Studebaker

SERVICE BULLETIN

NO. 262

1952

FIG. 2

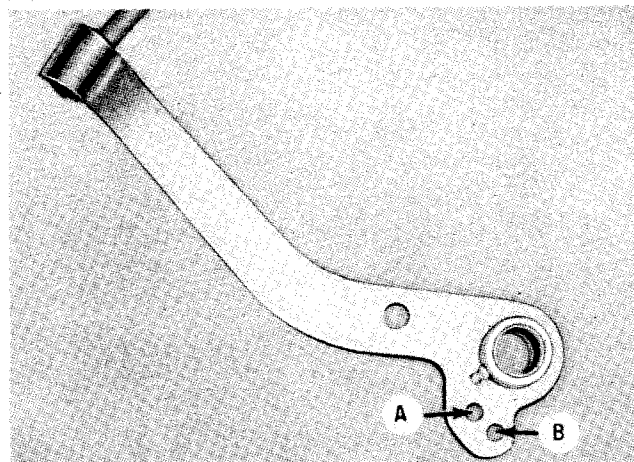
The change in linkage is shown in Fig. 2, which shows holes A and B in the brake pedal arm. On 1952 Commander (3H) models, hole A is used for the new master cylinder-to-brake pedal rod, Part No. 531865. Champion (12G) models use hole B for the master cylinder-to-brake pedal rod connection.

- a guide to maintain shoe location (not adjustment) by use of the slotted hole in the reverse shoe web. The cam need be turned only when grinding brake linings (see Item 6 below).
- There is no shoe return spring for the floating reverse shoes. The only return spring is connected between the forward shoe and the backing plate (3, Fig. 3).
 - The master cylinder-to-brake pedal rod is connected to the UPPER hole (A, Fig. 2) on all Commander (3H) models and to the LOWER hole (B, Fig. 2) on Champion (12G) models.
 - Insufficient pedal reserve can be caused by

FIG. 4

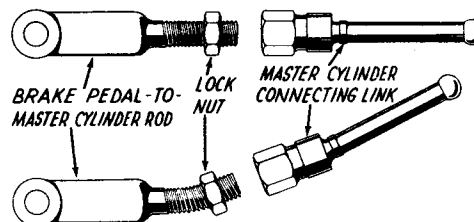
Excess or increase of brake pedal free travel (3) has several causes: (a) bent brake pedal rod (Fig. 4), (b) bent master cylinder connecting link (Fig. 4), (c) loose adjustment lock nut, or (d) loose master cylinder mounting bolts.

(c) INSPECT BRAKE PEDAL-TO-MASTER CYLINDER ROD AND ALSO THE MASTER CYLINDER CONNECTING LINK CAREFULLY FOR STRAIGHTNESS. If either part appears to be bent or damaged in any way or to any degree, discard it.

(d) Reassemble, using new parts if necessary (Part No. 523924, Master Cylinder Connecting Link; Part No. 531865, Pedal-to-Master Cylinder Rod), and adjust brake pedal free travel to specifications (1/16" to 3/16"). Tighten lock nut.

Do not adjust the master cylinder connecting link to correct excessive pedal free travel until after inspecting for a bent link or bent brake pedal-to-master cylinder rod.

FIG. 7

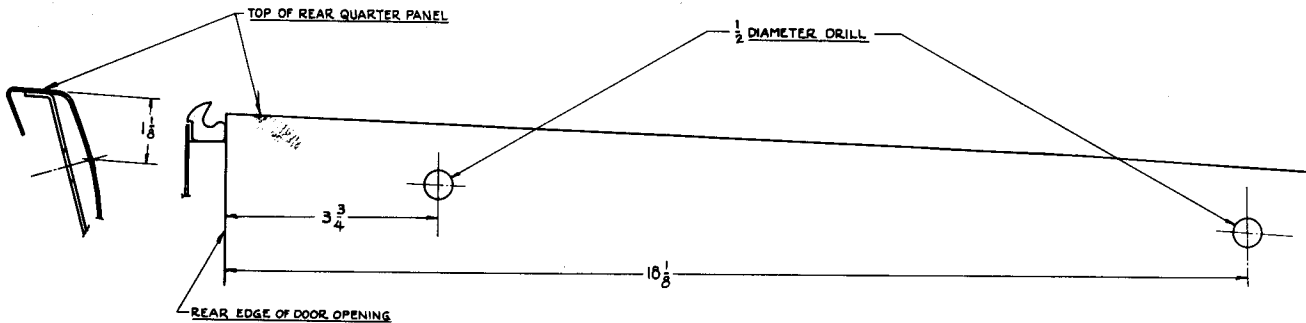
Effective with 12G Champion Serial No. G-1141024 and 3H Commander Serial No. H-8,250,134 the rear quarter panel belt moulding on Starliner models will be held in place by means of two studs instead of the clips and snap-on buttons used prior to the above serial numbers.

For installation of the new type moulding piece (Part No. 295944-5) on earlier production cars it will be necessary to drill two 1/2" diameter holes in the upper portion of the rear quarter panel as shown in the accompanying illustration (Fig. 7). The purpose of the oversize holes is to permit adjustment of the moulding location. The following parts must also be used:

Part No.	Part Name	No. Per Installation
295944	Belt moulding assembly, left rear quarter panel	1
295945	Belt moulding assembly, right rear quarter panel	1
295918	Stud seal	2
351-#10G	Fastening nut and washer assembly	2
41X358G	Plain washer	2

FIG. 8

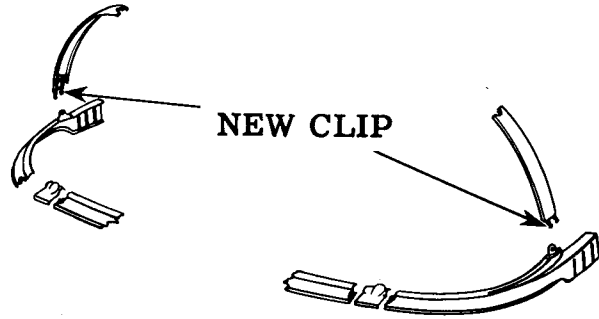
Originally the roof rear window moulding side piece on each side of 1952 Starliner bodies was held in place by a screw at the top and two clips along the side of the moulding. This piece has been changed to incorporate a clip riveted to the lower end of the moulding side piece so that the clip slips in behind the

rear quarter panel belt moulding (see Fig. 8).

A little material has been removed from the belt moulding to accommodate the added clip in the roof rear window moulding side piece.

The new side piece can be used on cars equipped with the original type if the attaching screw of the belt moulding is loosened slightly so that the clip on the side piece can be slid behind the moulding.

The new moulding side piece, with the clip riveted at the lower end, is Part No. 296599 (left) and 296598 (right).

FIG. 9

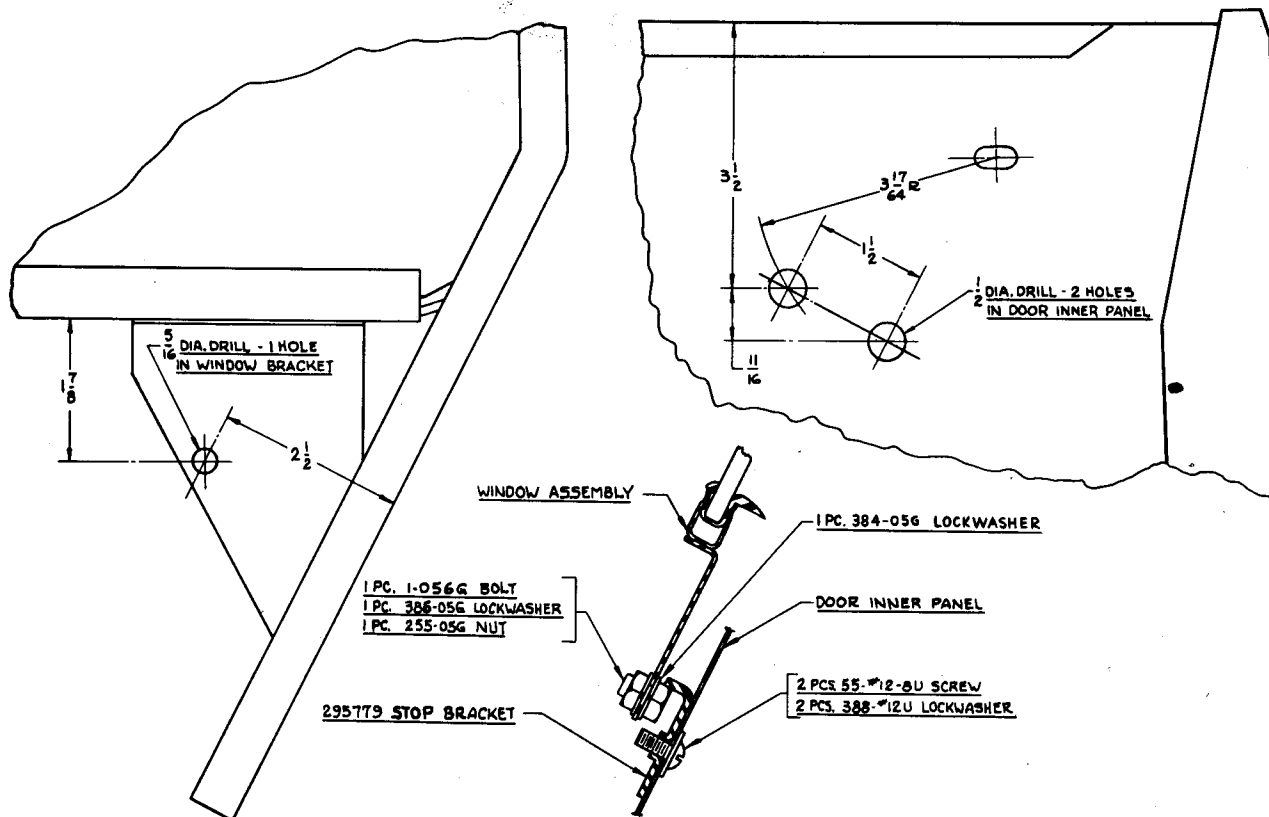
To provide a positive stop when raising the door glass of 1952 Champion and Commander convertible and Starliner models a bracket is being incorporated in production effective with Body Nos. 12G Champion Starliner 2327 and Convertible 207; 3H Commander Starliner 5187 and Convertible 295.

When it is desirable to install such a stop on cars previously built, refer to the drawing (Fig. 9) at each step and proceed as follows:

1. Remove door window glass assembly from door and drill a 5/16" hole in the door window bracket at the location shown in the drawing.
2. Drill two 1/2" diameter holes in door inner panel at the locations shown in the drawing.
3. Replace door glass assembly in door. Install 386-05G lock washer on the bolt and in the hole drilled in the door window bracket. Then install 384-05G lock washer and 255-05G nut on the bolt.
4. Lower window so that nut and bolt just installed in window bracket is below location of stop bracket and install the stop bracket in the door panel.

Part No.	Part Name	No. Required Per Window
295779-G	Stop Bracket	1
55-#12-8U	Screw	2
388-#12U	Lock Washer	2
1-056G	Bolt	1
384-05G	Lock Washer	1
255-05G	Nut	1
386-05G	Lock Washer	1

FIG. 10

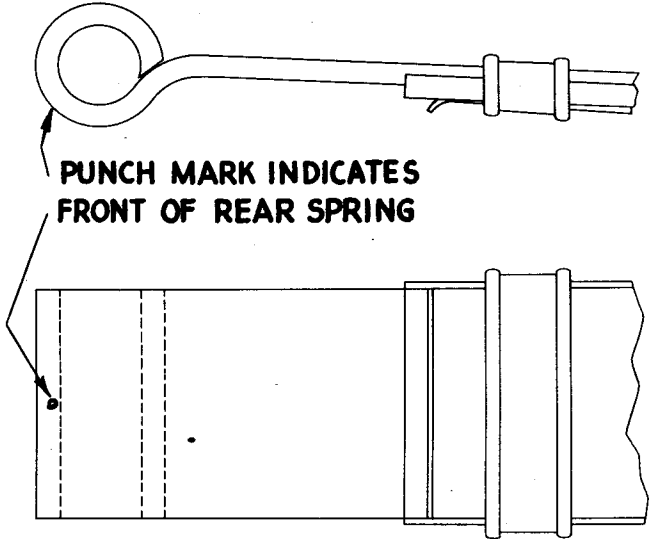
When rear springs for 1951 and 1952 passenger car models are made, the center bolt hole is punched 25 inches to the rear of the center of the front eye of the spring. Thus it is possible that the rear section of the spring may vary slightly more or less than 25 inches from the center bolt hole to the center of the rear eye.

In order to assure that these springs are installed properly, a dimple is punched into the outer surface of the front eye (see Fig.10). Rear springs should always be installed, therefore, with this dimple toward the front of the car.

FIG. 11

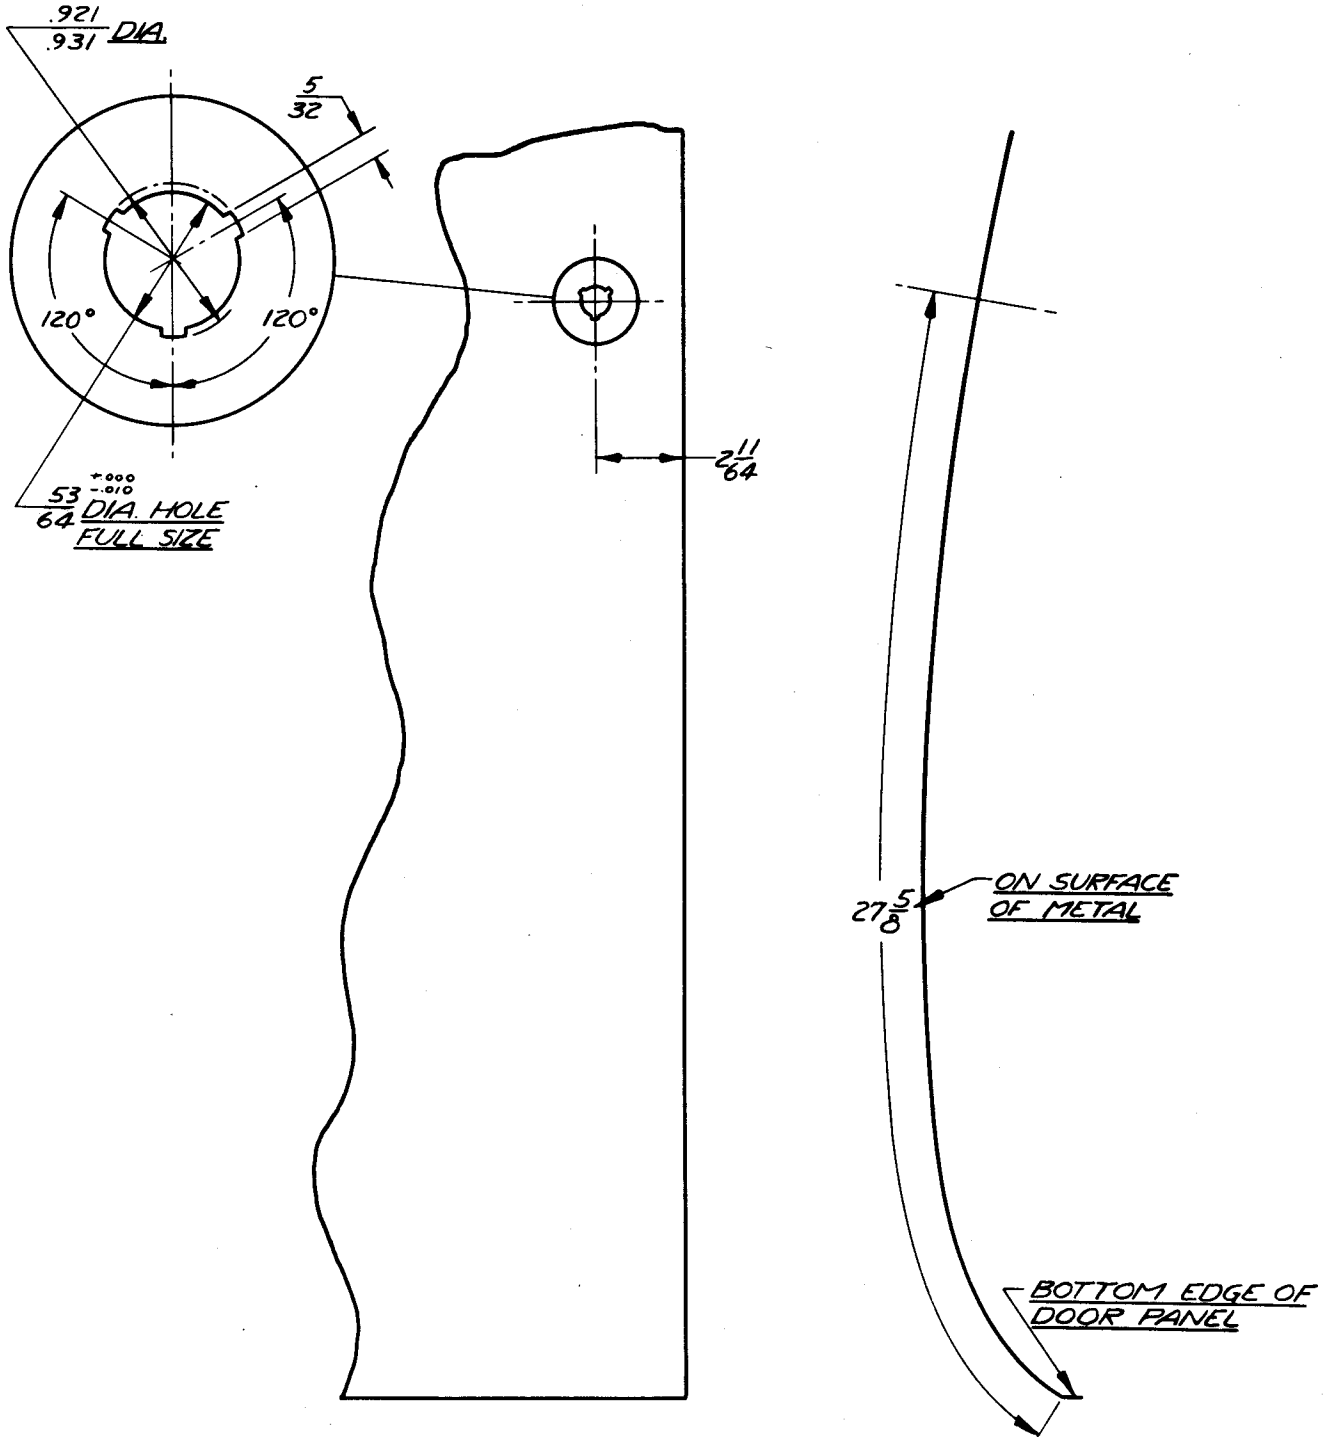
It is occasionally desirable to install an outside door lock on the driver's door of a 2R Series truck. If the customer wants the

lock to be operated by his present ignition key, it will be necessary to take the lock cylinder and ignition key to a local locksmith who will be able to change the tumbler combination of the new lock cylinder to match the present ignition key.

1. Measure locating lines on outer door panel exactly as shown in Fig. 11.
2. Scribe a circle of 15/32" radius, using the intersection of the locating lines for a center.

3. Center punch this point and drill a 53/64" diameter hole.
4. File three notches at 120° intervals, each notch to be 5/32" wide and to the depth of the circumference of the circle scribed in Step 2.
5. Remove original Rotary door lock assembly.
6. Parts to be installed include:

Part No.	Part Name
265165	Door Lock Assembly
652798	Lock with Keys
271441	Retainer
